Project	IEEE 802.16 Broadband Wireless Access Working Group < <a href="http://ieee802.org/16">http://ieee802.org/16</a> >	
Title	Fixes for Network Entry Flow Charts	
Date Submitted	2007-03-13	
Source(s)	Nadav Lavi et al Alvarion Ltd. [Address Line 1] [Address Line 2]	Voice: +97236457834 Fax: [Fax Number] <a href="mailto:Nadav.lavi@alvarion.com">[mailto:Nadav.lavi@alvarion.com]</a>
Re:	IEEE Std 802.16-2004/Cor2/D2	
Abstract	Fixes for Network Entry Flow Charts in 802.16-2004/Cor2/D1	
Purpose	For the review in 802.16 Maint TG	
Notice	This document has been prepared to assist IEEE 802.16. It is offered as a basis for discussion and is not binding on the contributing individual(s) or organization(s). The material in this document is subject to change in form and content after further study. The contributor(s) reserve(s) the right to add, amend or withdraw material contained herein.	
Release	The contributor grants a free, irrevocable license to the IEEE to incorporate material contained in this contribution, and any modifications thereof, in the creation of an IEEE Standards publication; to copyright in the IEEE's name any IEEE Standards publication even though it may include portions of

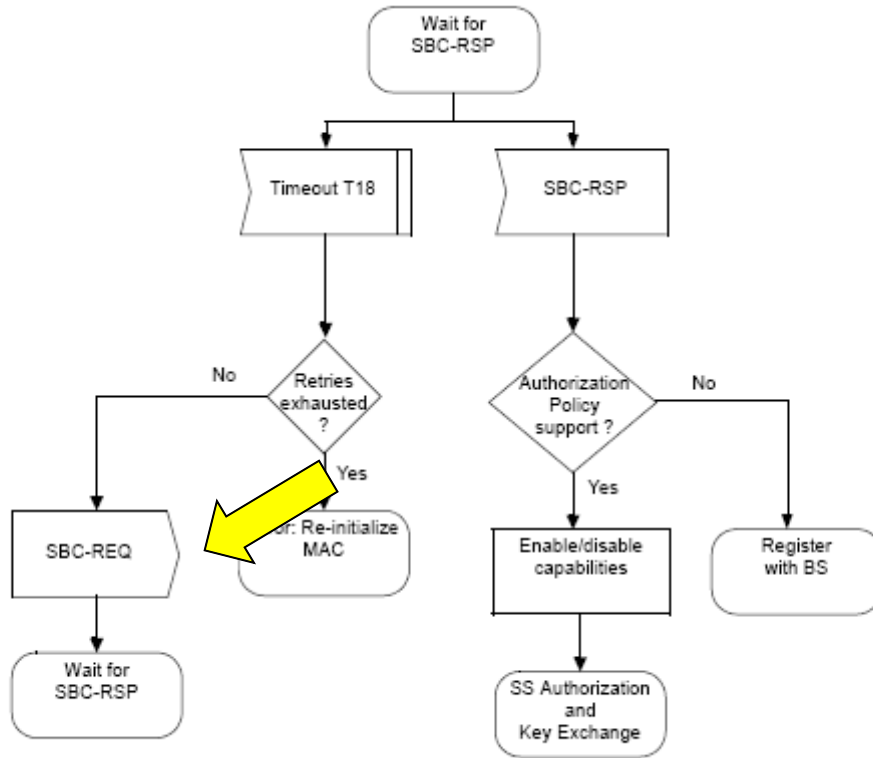
There is an unclear definition of how to handle expiration of T9 in the BS side in SBC transaction, and expiration of T17 in the BS side in REG transaction. The condition for “Release and age-out connections” is unclear and not well defined. In addition, this action is local to the BS and thus remains unknown to the SS. We suggest that the BS would send unsolicited RNG-RSP message with Abort instruction when these timers expire. The current Network Entry flow chart cannot handle retransmission, either due to processing delays or message drop. After the BS transmits a response message, it will proceed directly to the next state in the Network Entry flow and thus cannot handle a retransmission of request by the SS; this would cause the Network Entry procedure to end in failure. For example, the following flow chart (Figure 67 in 802.16e-2005) shows that BS sends SBC-RSP.

If the SS does not receive SBC-RSP within T18 timeout, it will retransmit the SBC-REQ (Figure 66).

Figure 70—Registration—BS

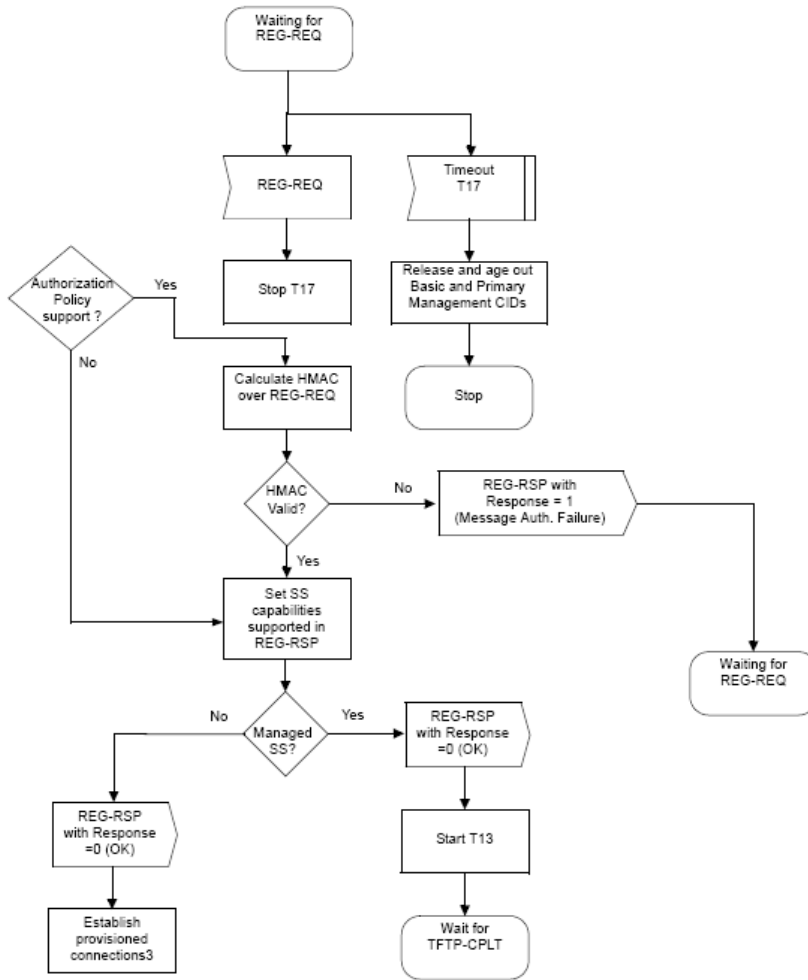
However after sending SBC-RSP, the BS proceeds directly to the registration step. The corresponding flow chart (Figure 70) does not contain any state where a retransmission of SBC-REQ can be received and processed. This is just an example of one single scenario. Similar failures can be identified for other steps in the entire Network Entry flow.

We suggest the Network Entry process be specified using 1) Network Entry state machine, and 2) set of actions/procedures of handling the Network Entry messages. This will provide a clearer definition of the network entry procedure as well as the handling of error/failure conditions.

Figure 67a-Handle SBC-REQ first reception, BS side.

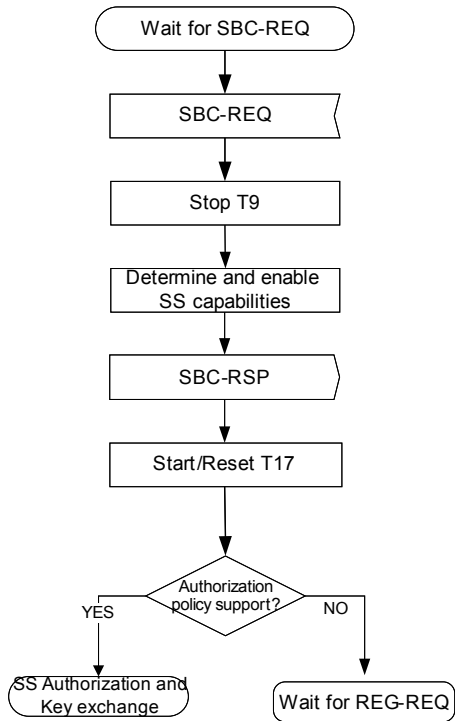
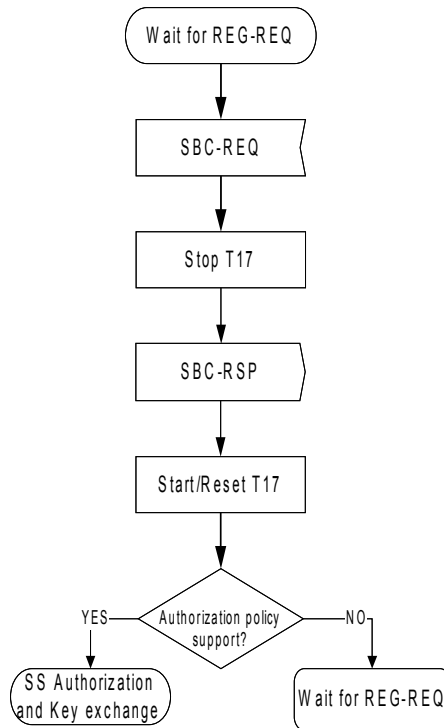
*In 802.16-2004/Cor2/D2, replace Figure 67 in 6.3.9.7 with the following Figure 67a and 67b:*

Figure 69 – Handle REG-RSP, SS side.

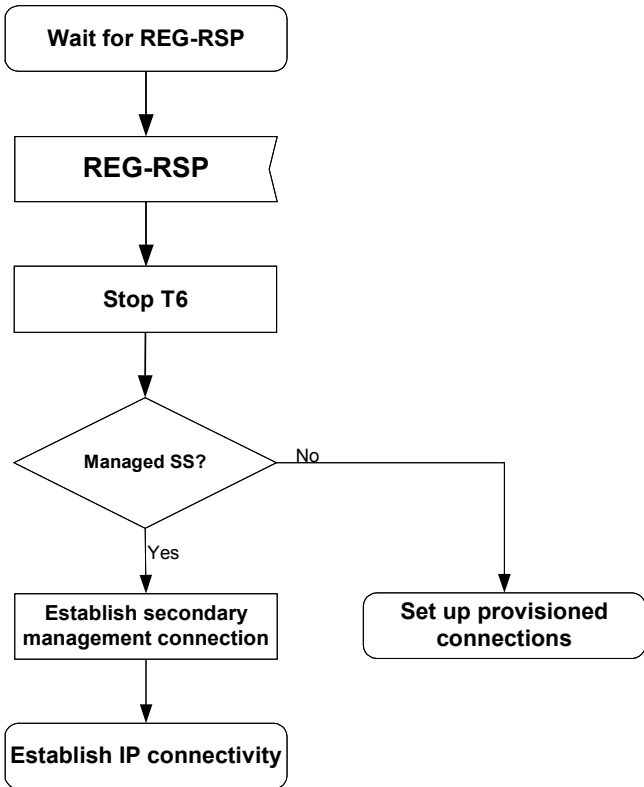
*In 802.16-2004/Cor2/D2, replace Figure 69 in 6.3.9.9 with the following figure:*

Figure 70a – Handle REG-REQ first reception (BS side).

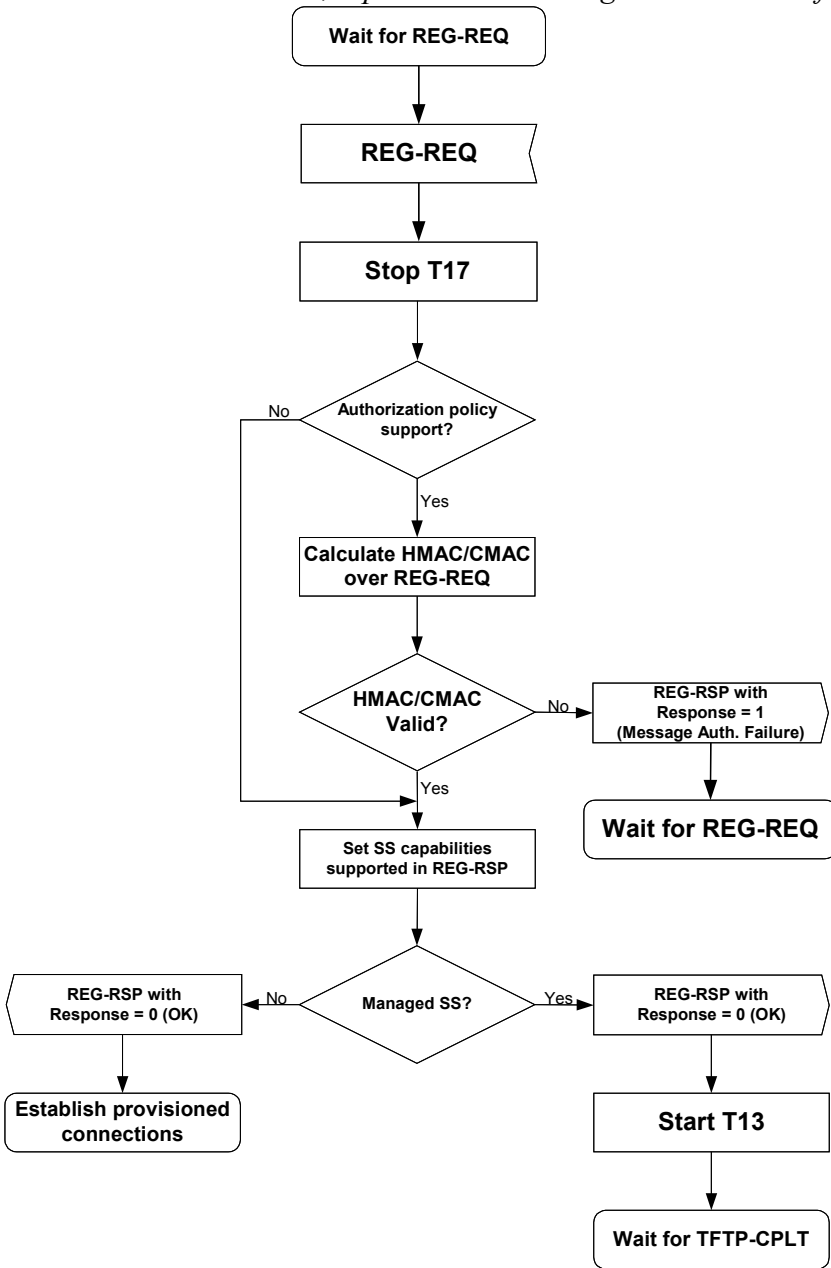
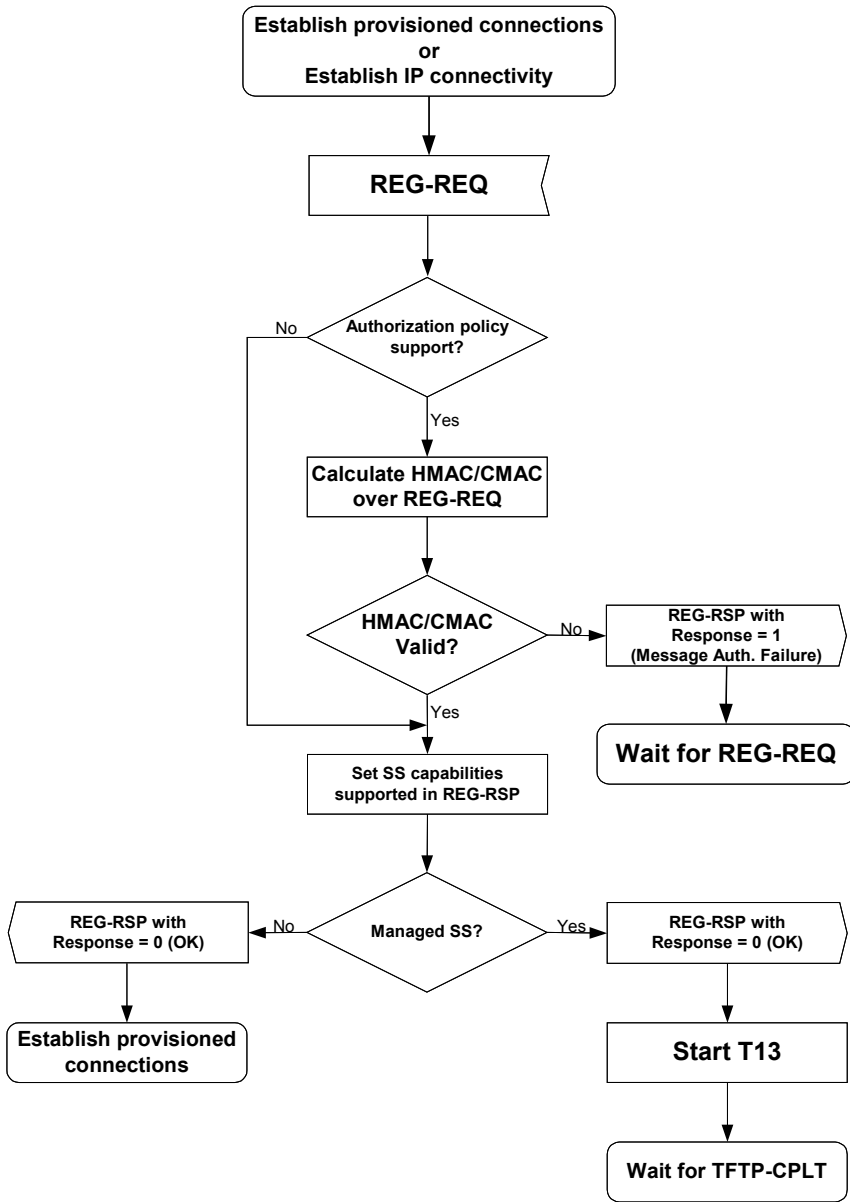
In 802.16-2004/Cor2/D2, replace in 6.3.9.9 Figure 70 with the following Figure 70a and Figure 70b:

Figure 66 – Handle SBC-RSP, SS side.

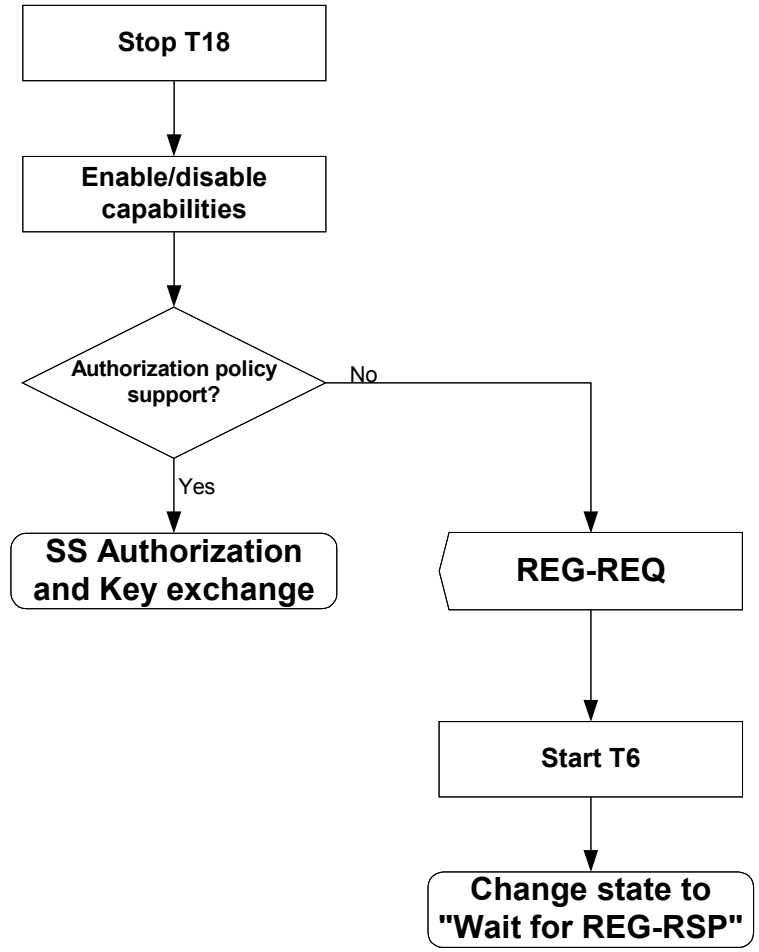
In 802.16-2004/Cor2/D2, Replace Figure 66 in 6.3.9.7 with the following figure:

Figure 87a – Handle CDMA Initial Ranging Code at BS

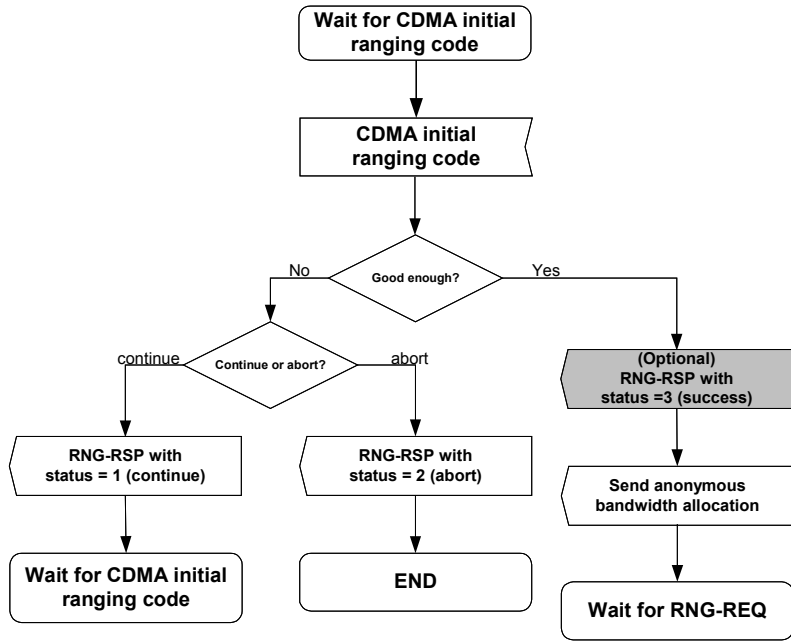
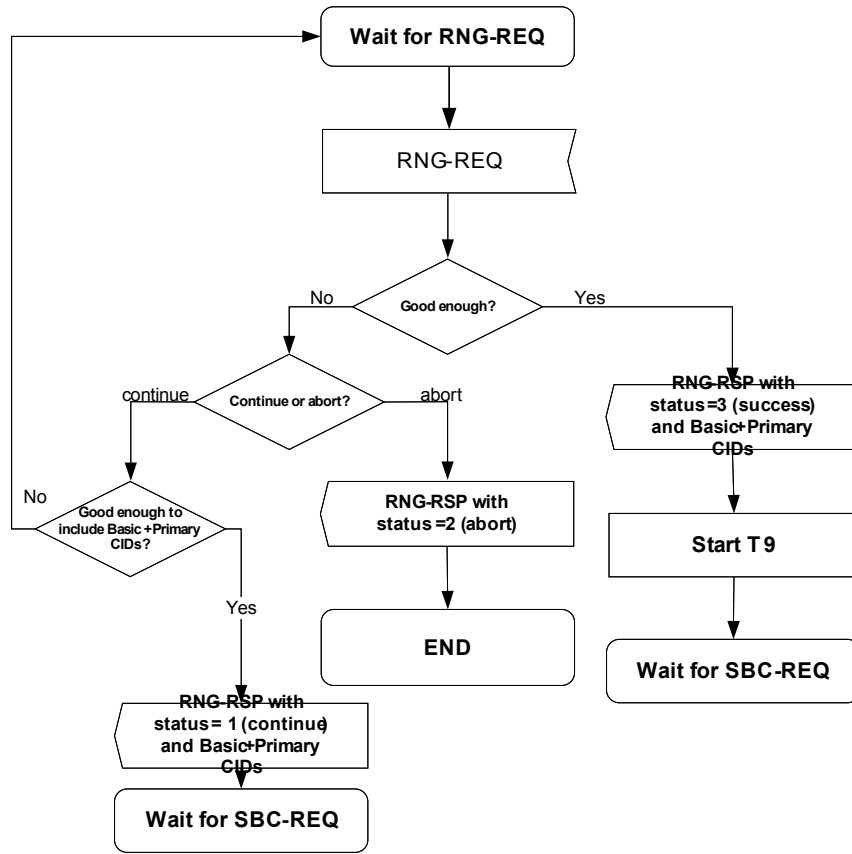
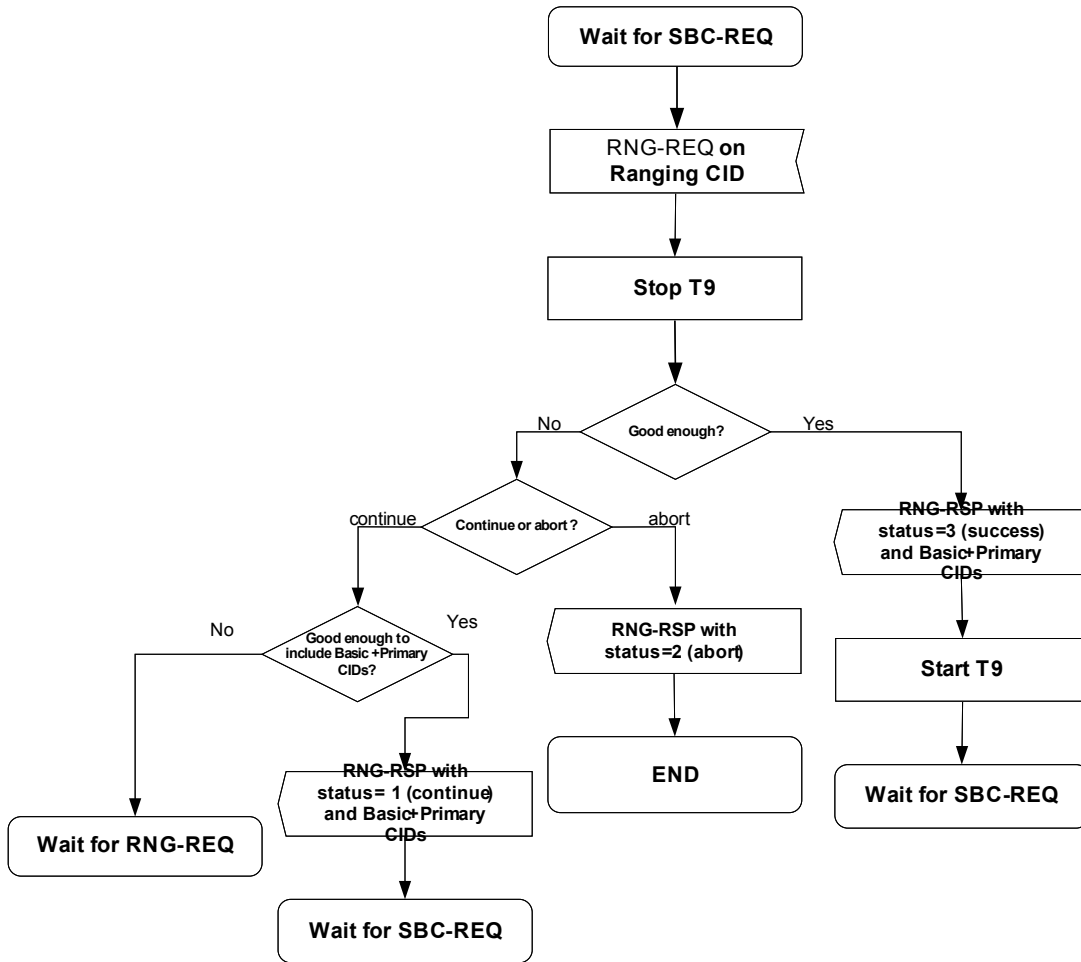
There is an ambiguity as to whether or not the BS must send an RNG-RSP message with status success when there are no corrections, or if it can just send a CDMA\_Allocation\_IE.

In 802.16-2004/Cor2/D2, replace Figure 87 with the following Figure 87a, Figure 87b and Figure 87c:

When the BS receives an initial-ranging CDMA code that requires no corrections ~~results in sending an RNG-RSP message with success status~~, the BS shall provide BW allocation for the SS using the CDMA\_Allocation\_IE to send an RNG-REQ message. Sending RNG-RSP message with status "Success" is optional.

Figure 70c – Network entry state-machine BS side

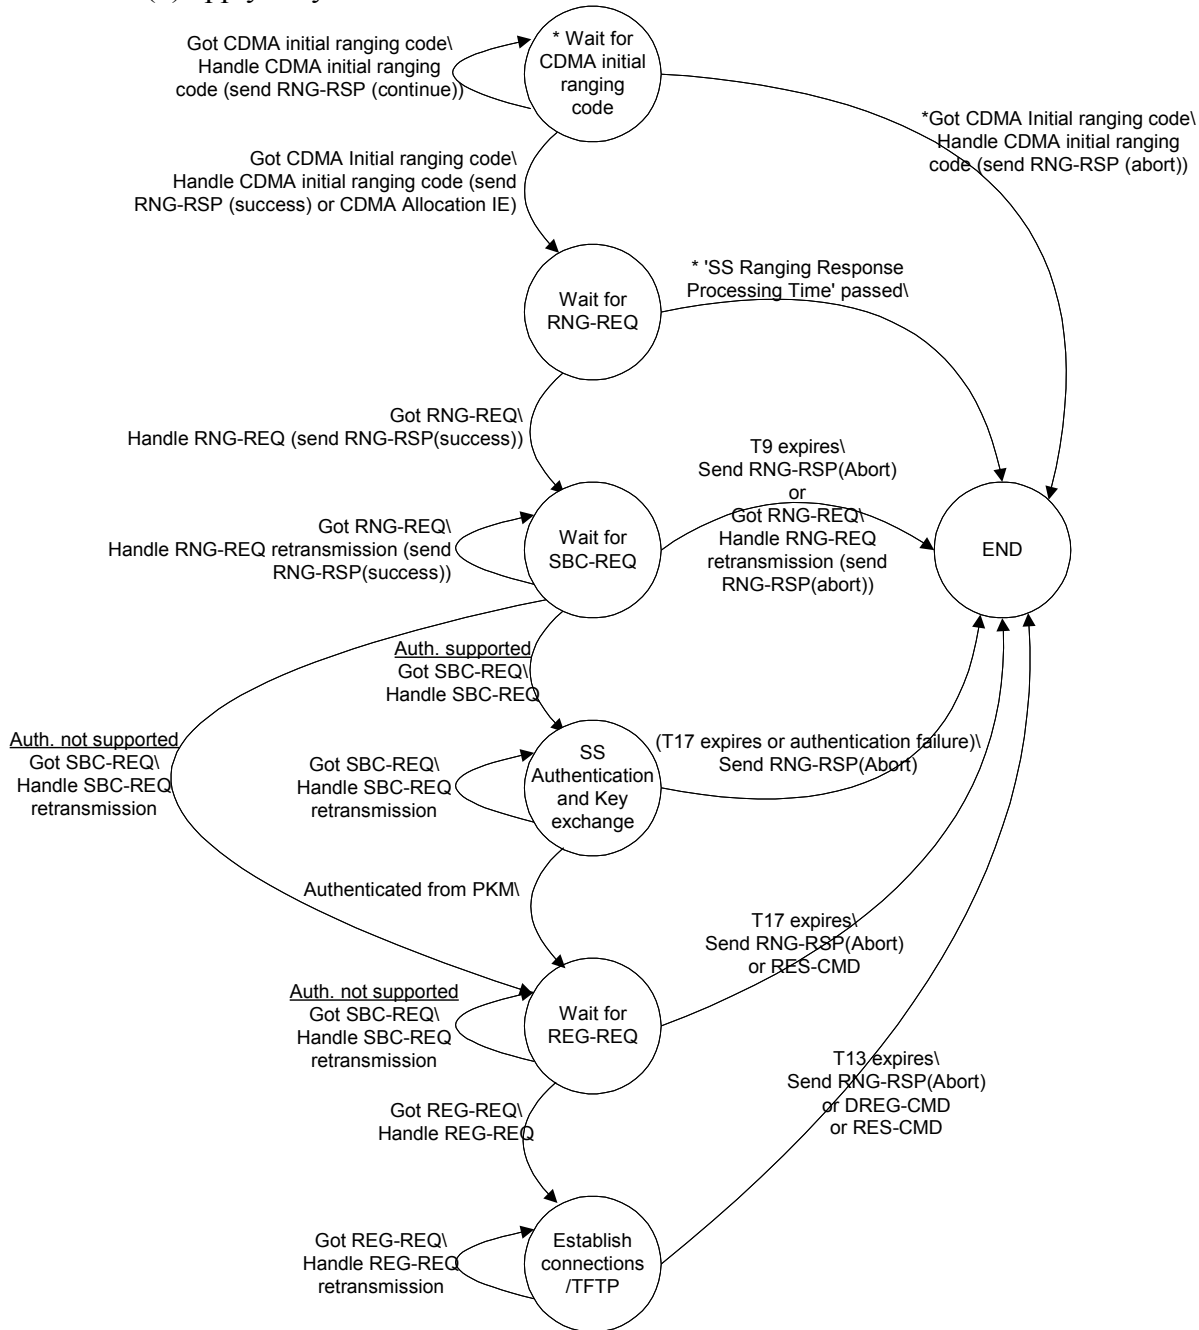
In 802.16-2004/Cor2/D2, add the following text at the end of Section 6.3.9.9, and change Figure 70a with the following Figure 70c:

The following Figure describes the NW entry process on BS side. The transitions and states that are marked with asterisks (\*) apply only to OFDMA PHY.
